ENVIRONMENTAL REVIEW TEAM REPORT

IVY WOODS SUBDIVISION
WOODBURY, CONNECTICUT

JULY 1979

The Town of Woodbury, Connecticut is presently reviewing a preliminary application for subdivision of ± 300 acres of land. The subject site is located in the northcentral portion of town, just west of Flanders Road.

FIGURE 8.
VEGETATION TYPE MAP

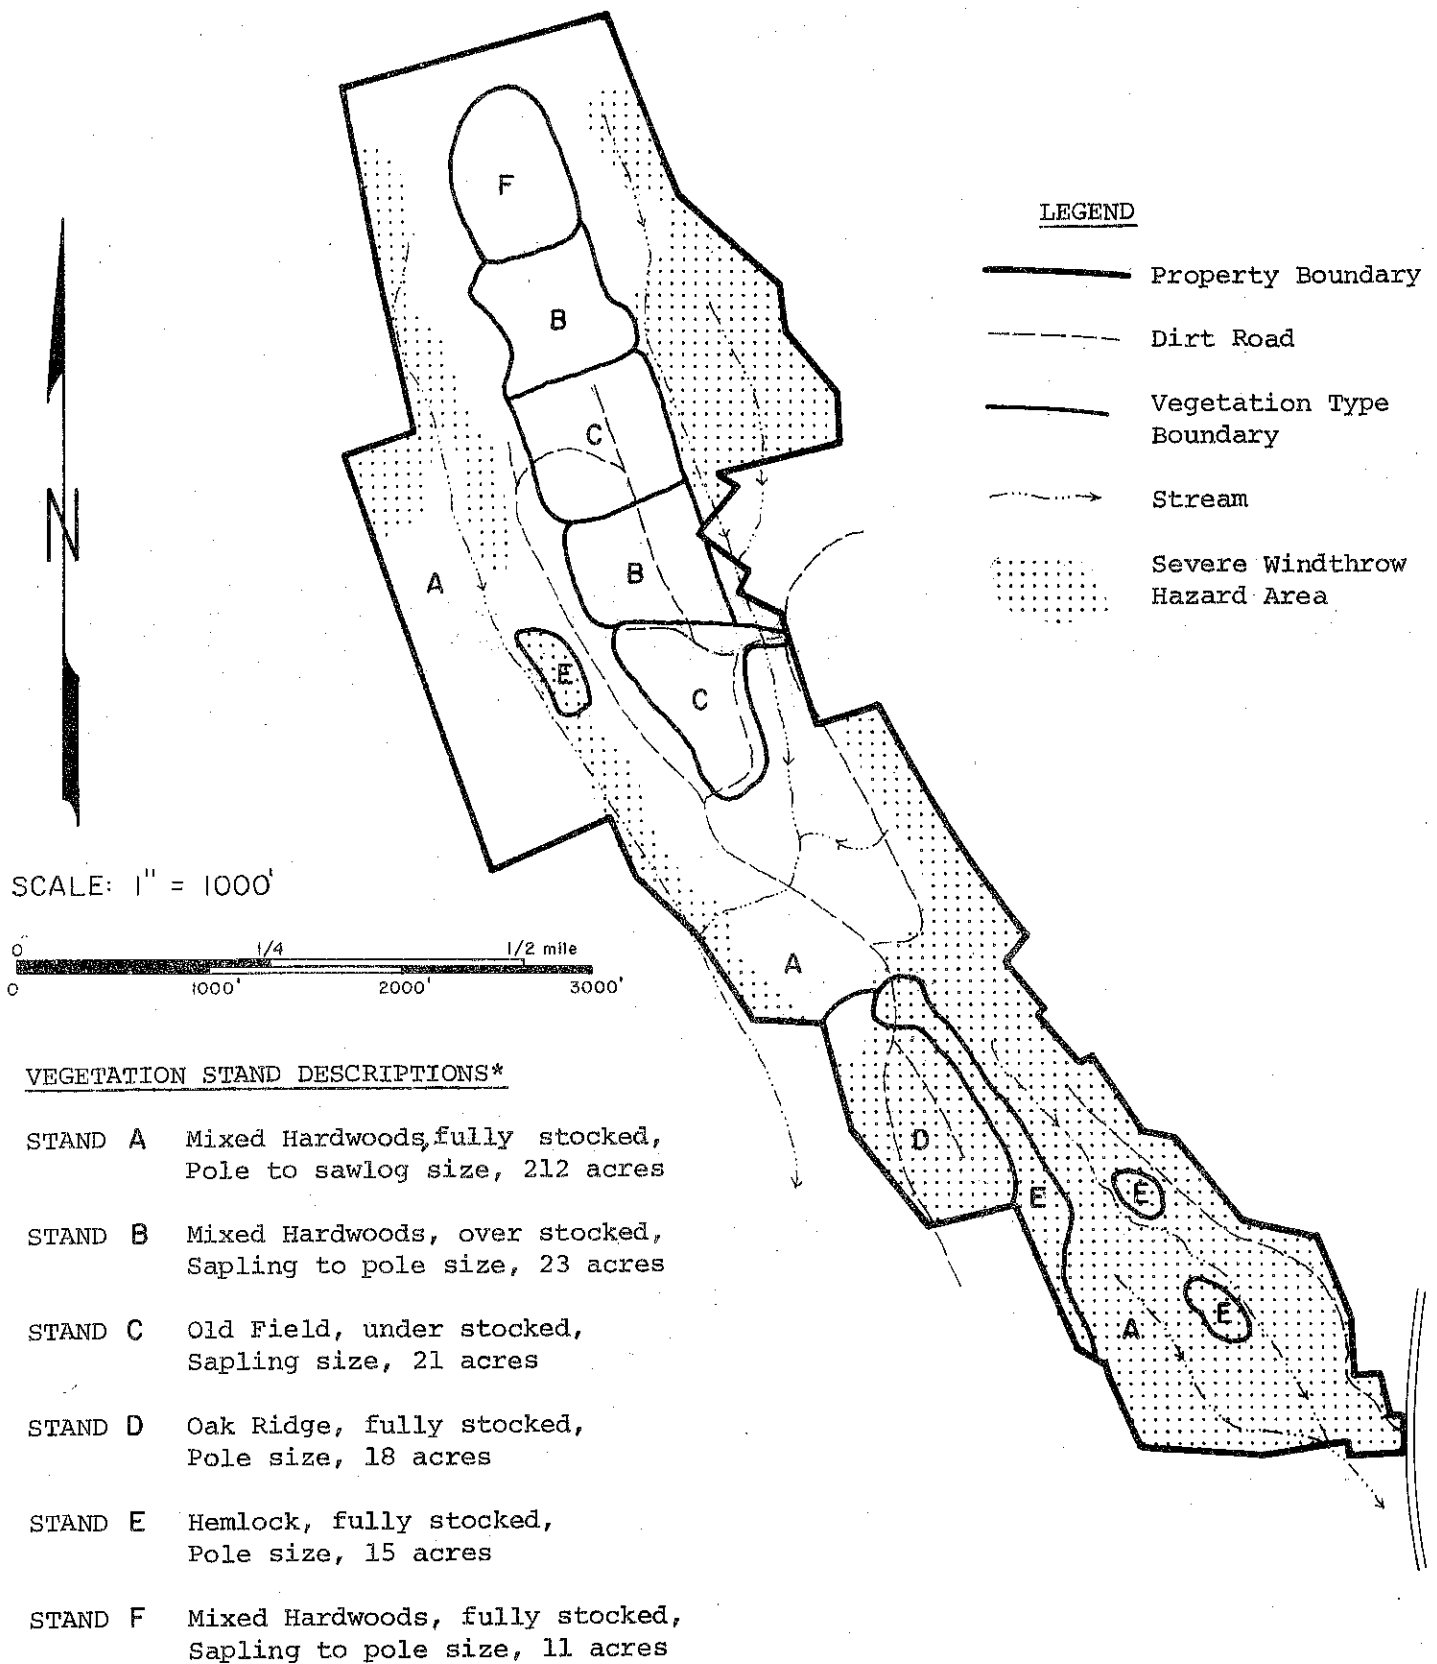
The ± 300 acre site proposed for the Ivy Woods Subdivision is completely forested. Six distinct vegetation stands are present on the property (see Figure 8). Presented below is a description of each of these stands, followed by a discussion of a number of forestry related concerns.

The excessively drained and shallow to bedrock soils in parts of Stand A (shaded portions on vegetation type map), and all of Stand D and E, limit tree growth rates and to some extent restrict species composition. The lack of adequate moisture, especially during the spring rapid growth season causes the trees (particularly in Stand D, Oak Ridge) to be slow growing and even stunted. It is not economically feasible to manage Stands D and E for timber production.

Windthrow is a severe hazard in parts of Stand A and most of Stand D and E (see vegetation type map, severe windthrow hazard area). The soils in these areas are shallow to bedrock and tree root systems are of limited depth. This hazard is lessened where the underlying bedrock is highly fractured, because tree roots can penetrate deeper and become more securely anchored. The windthrow hazard is increased in the valley bottoms even though the soils are somewhat deeper, because availability of adequate moisture has resulted in taller growing trees. These tall trees rely on each other for wind firmness and overall stability. Large openings made in these areas which allow wind to pass through rather than over these stands may increase the windthrow hazard. The creation of such openings should be avoided where possible.

A light thinning in the part of Stand A where the windthrow hazard is high may, over time, increase wind firmness by reducing competition between residual trees. This reduction of competition should cause an increase in root and crown spread and, in turn, improve stability.

As mentioned earlier, a light thinning in those parts of Stand A where the windthrow hazard is severe, should help to increase wind firmness and improve the stability of the residual trees. Ideally these thinnings should be implemented several years before any further development takes place. This will give the residual stand a chance to become healthier and more stable, and better able to withstand the disturbances caused by subdivision of the property. At the time of thinning, a trail network and perhaps a picnic area could be laid out in the open space area to provide an added amenity to the subdivision.

FIGURE 9.

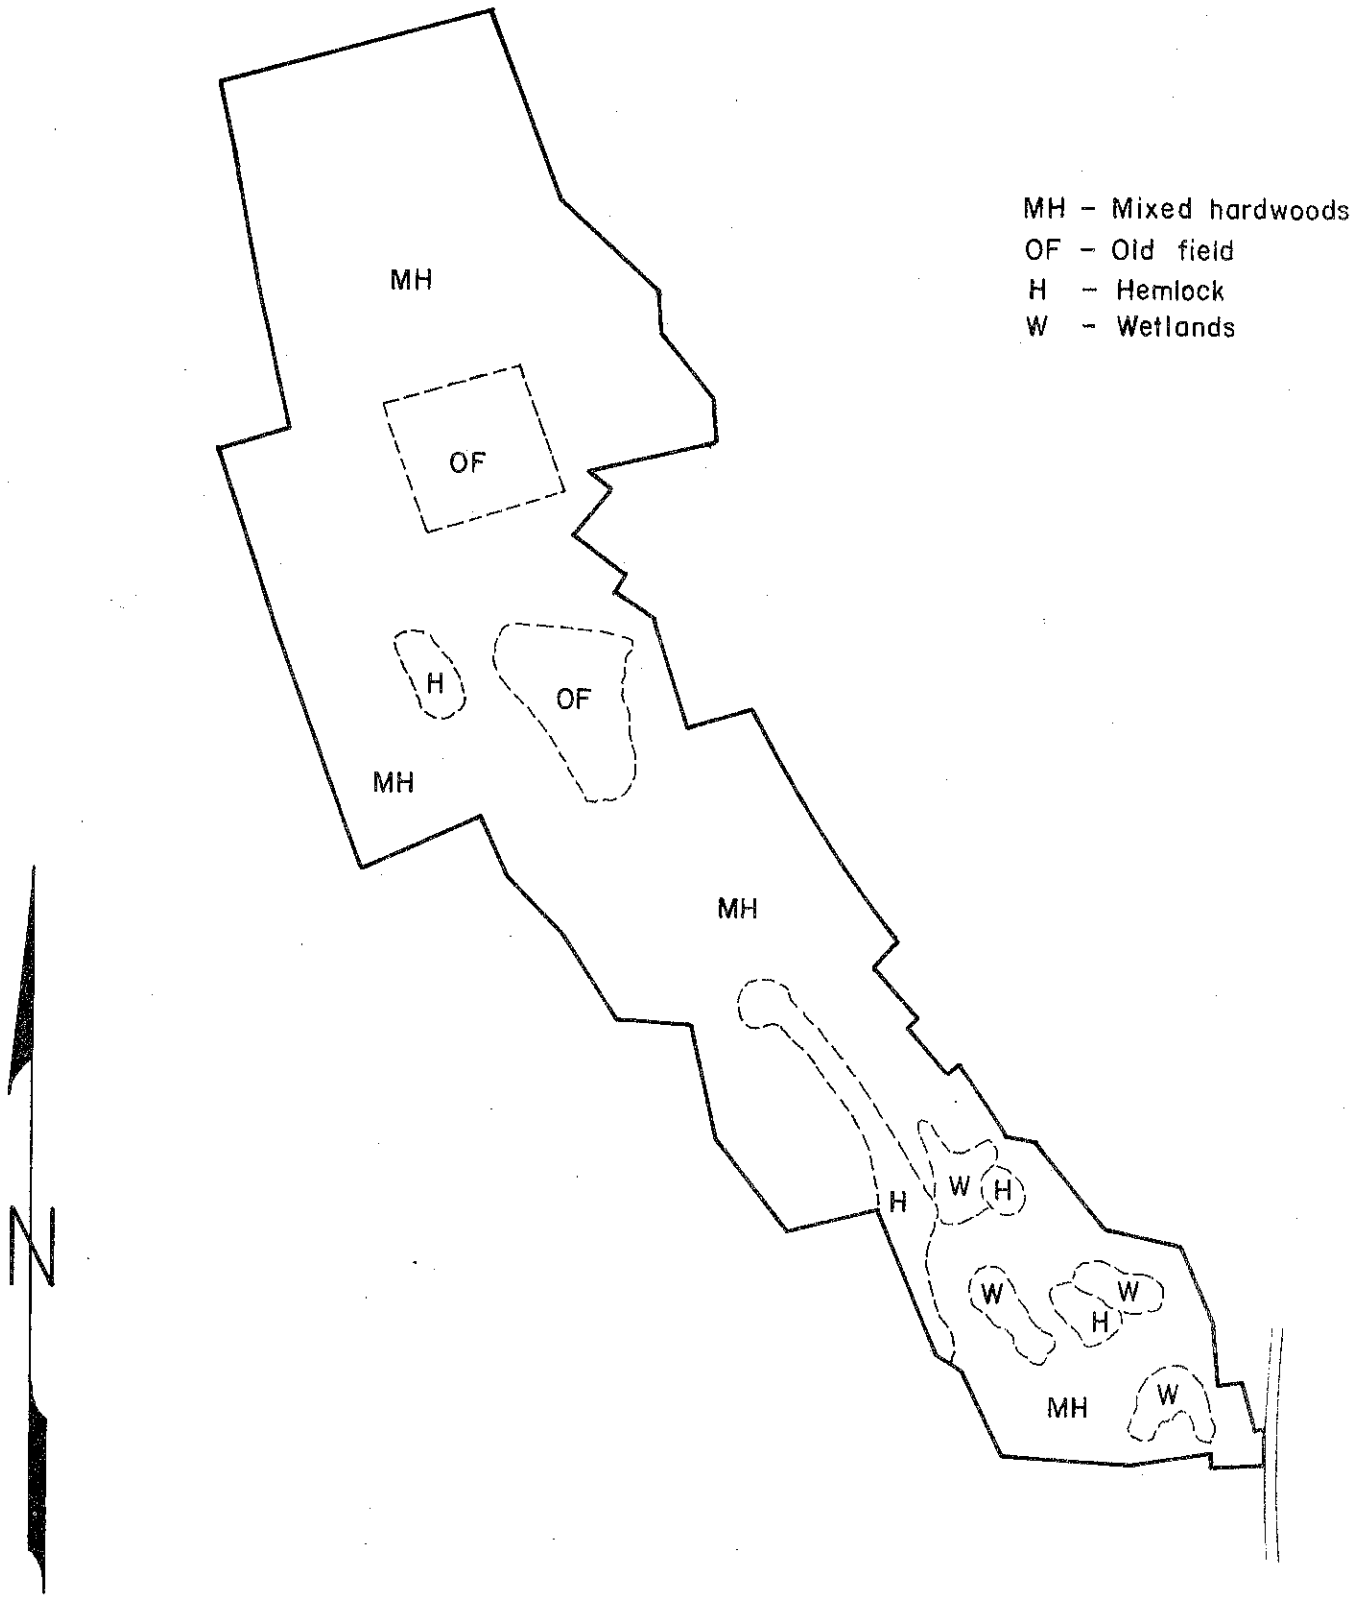
The 300 acre Ivy Woods site includes four wildlife habitat types. The distribution of these types is shown in Figure 9.

The wetland and abandoned field sections of this parcel are the most valuable wildlife habitats. Leaving these areas as open space will incur the least unfavorable impact on the wildlife present.
